**CERTIFICATE OF COMPLIANCE
FOR SPENT FUEL STORAGE CASKS**

Certificate No.	Effective Date	Expiration Date	Docket No.	Amendment No.	Amendment Effective Date	Package Identification No.
1014	05/31/00	06/01/20	72-1014	3		USA/72-1014

Holtec International
Final Safety Analysis Report for the
HI-STORM 100 Cask System

**TECHNICAL SPECIFICATIONS
FOR THE HI-STORM 100 CASK SYSTEM**

Figure 2.1-2
Fuel Loading Regions - MPC-24E/24EF

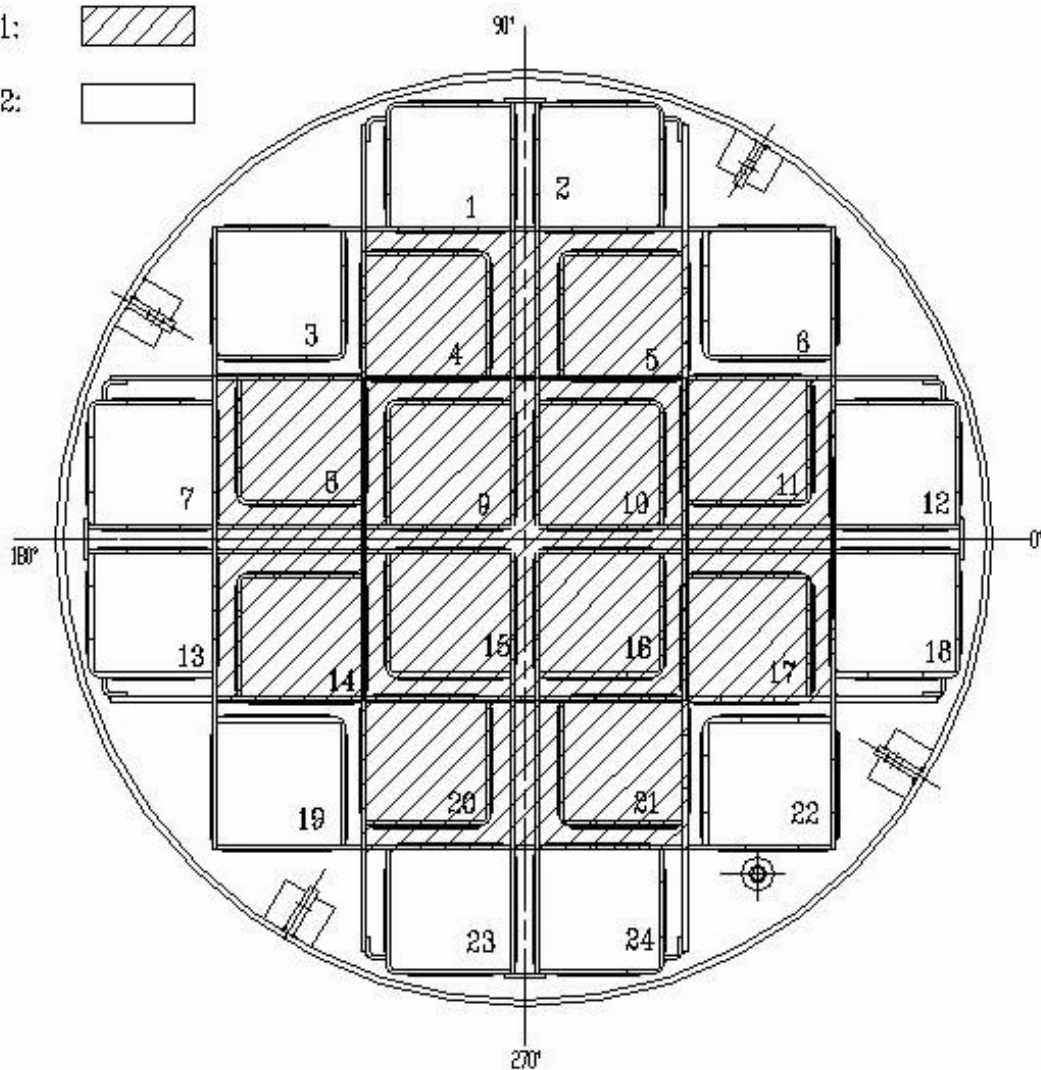
- B. Quantity per MPC: Up to four (4) DAMAGED FUEL ASSEMBLIES and/or FUEL DEBRIS in DAMAGED FUEL CONTAINERS, stored in fuel storage locations 3, 6, 19 and/or 22 (see Figure 2.1-2). The remaining MPC-24EF fuel storage locations may be filled with PWR INTACT FUEL ASSEMBLIES meeting the applicable specifications.

Figure 2.1-3
Fuel Loading Regions - MPC-32/32F

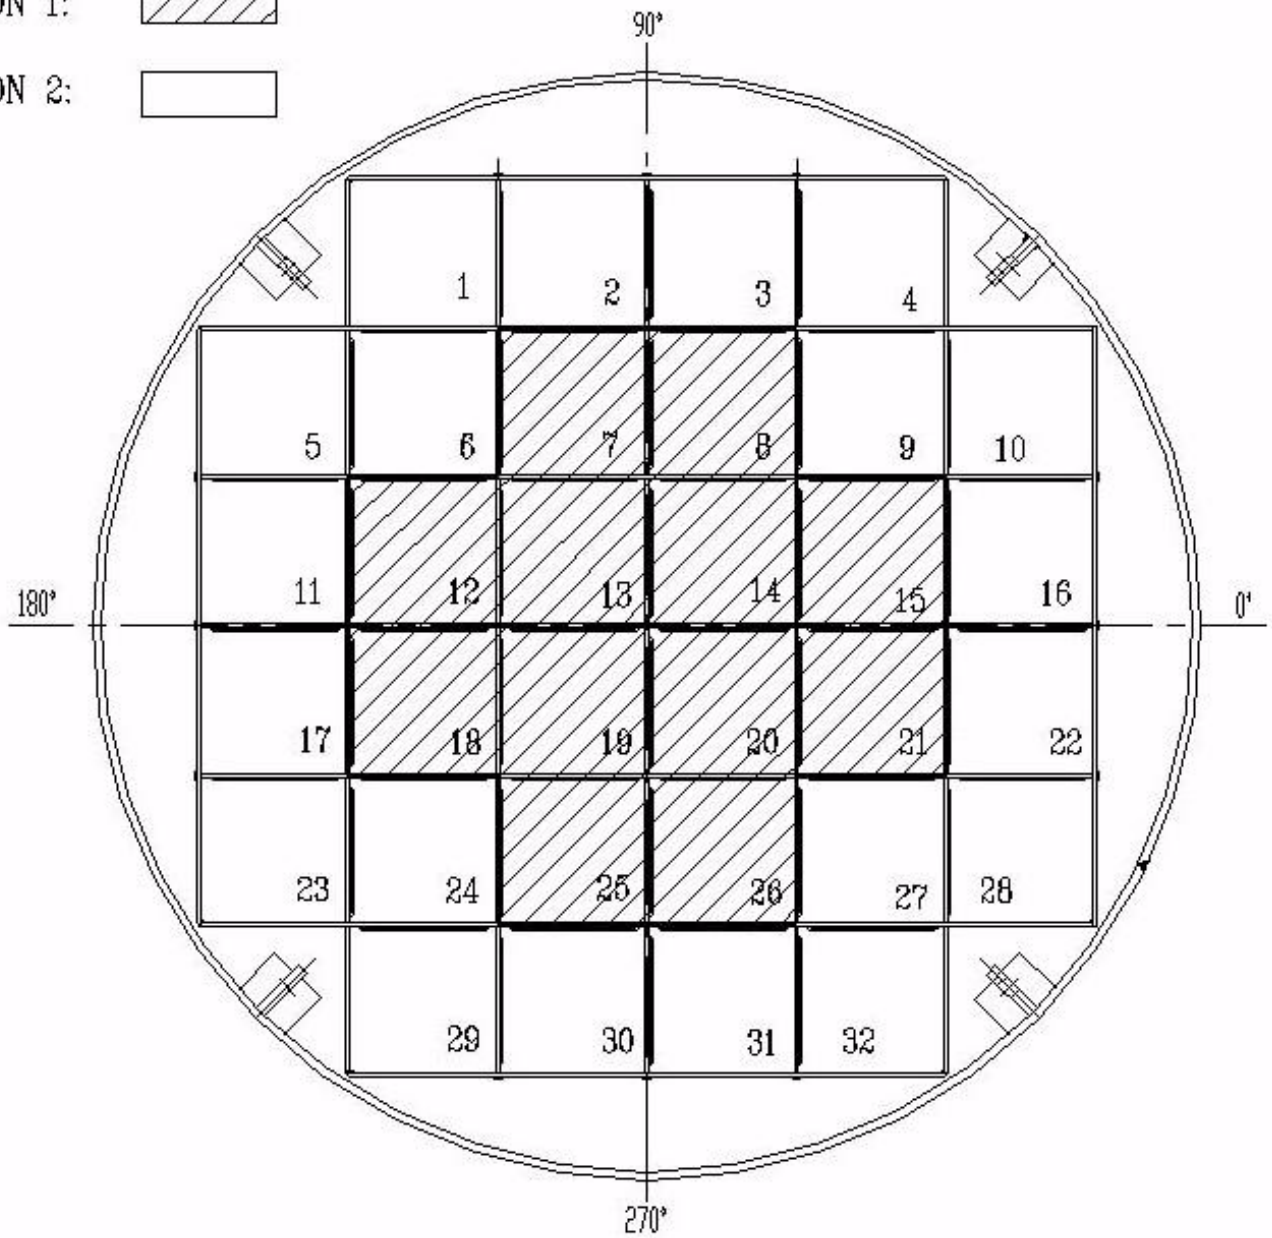
B. Quantity per MPC: Up to eight (8) DAMAGED FUEL ASSEMBLIES and/or FUEL DEBRIS in DAMAGED FUEL CONTAINERS, stored in fuel storage locations 1, 4, 5, 10, 23, 28, 29, and/or 32 (see Figure 2.1-3). The remaining ~~MPC-32F~~ fuel storage locations may be filled with PWR INTACT FUEL ASSEMBLIES meeting the applicable specifications.

Figure 2.1-4
Fuel Loading Regions - MPC-68/68FF

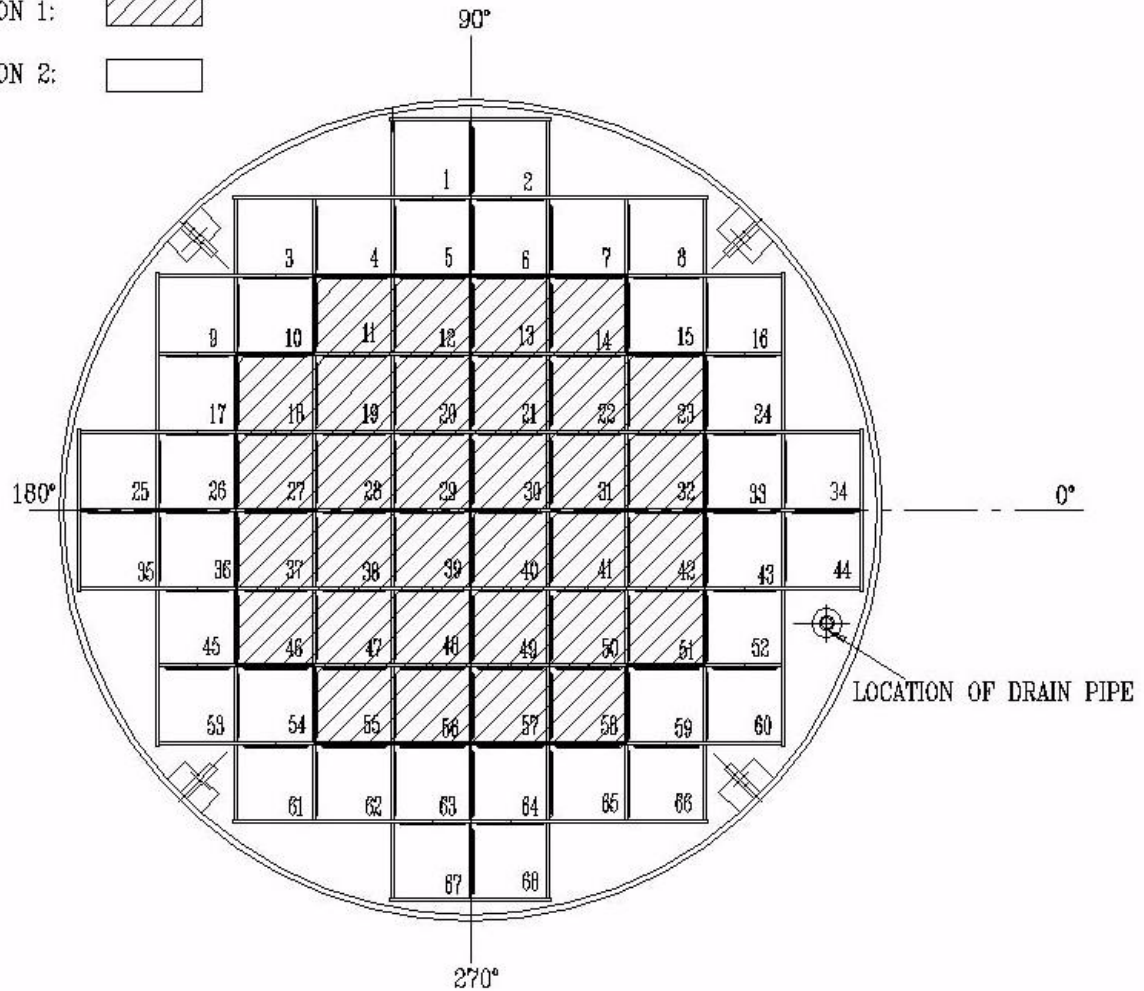
D. Array/Class 10x10D and 10x10E fuel assemblies in stainless steel channels must be stored in fuel storage locations 19 - 22, 28 - 31, 38 -41, and/or 47 - 50 (see Figure 2.1-4).
